City of Portland
 Development Review Application
 Planning Division Transmittal Form

Application Number: 2013-269 **Application Date:** 12/16/2013
CBL: 192 C001001 **Application Type:** Level I Site Alteration
Applicant: CITY OF PORTLAND /Doug Roncarati
Project Name: Rockland Avenue Outfall
Address: 0 CAPISIC ST
Project Description: Capisic Pond park, on the north side of Capisic Street, west Stevens Avenue, in the Rosemont Neighborhood.

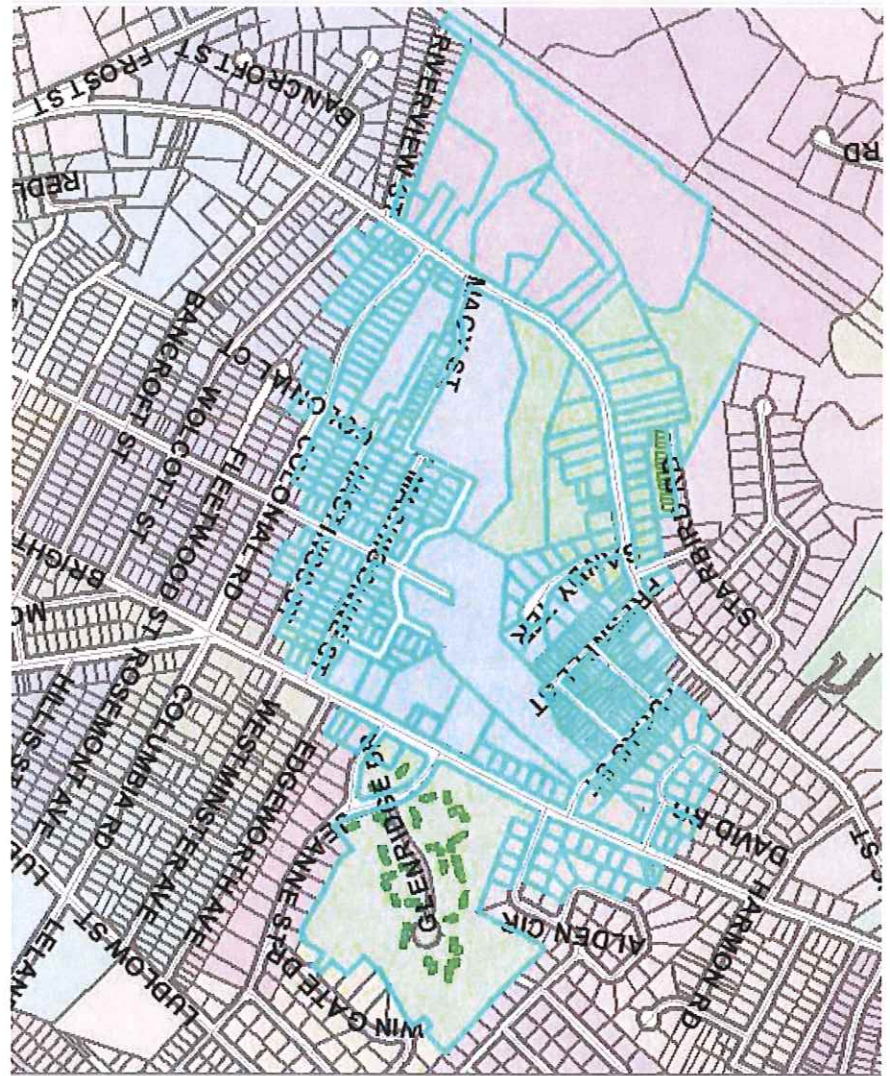
My impression is that its odd to have so much landscaping etc by the outfall and nothing at all here - but I understand the reasons and constraints.

I will await the final site plan- Lauren, just shown the final surface conditions for all of the disturbed area not included in the Landscape Plan.

REINFORCED MAINTENANCE ACCESS N.T.S.

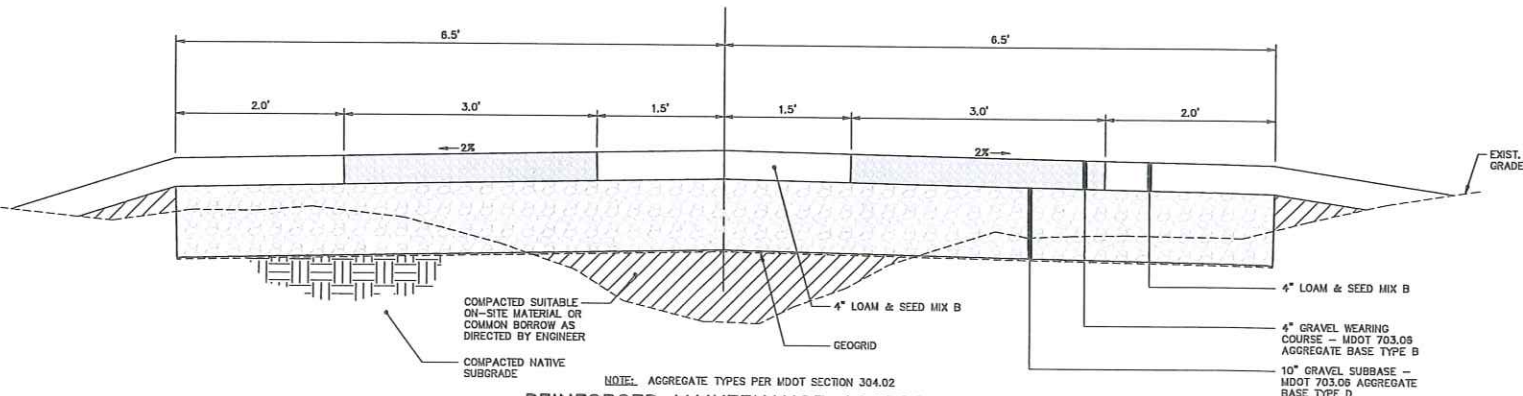
We are creating a figure to clearly show the proposed conditions at the site to help address your original questions about the site plan. We can show more clearly what the reinforced maintenance access way will look like on the plan. Per the detail on sheet C-301, there will be 3' strips of gravel wearing course, with loam and seed to surround those gravel areas. The intent is not for the maintenance access to be overly intrusive. There will be a gravel subgrade beneath the gravel strips and the loam and seed so that trucks can drive over the area to access the stormwater treatment unit.
